Tripple Seven Apparels Ltd(10069)

08.07.2014

Identified Priority 1 Concerns

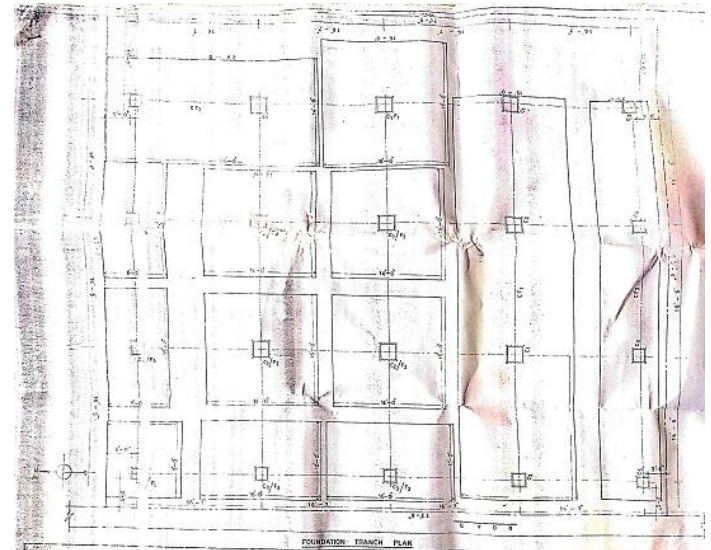
- Discontinued beam (photo from 5th floor, building 1)
- Ensure that loads in this area are not increased beyond current levels, and maintain constant surveillance until an Engineering Assessment is carried out to check if this condition meets BNBC requirements.
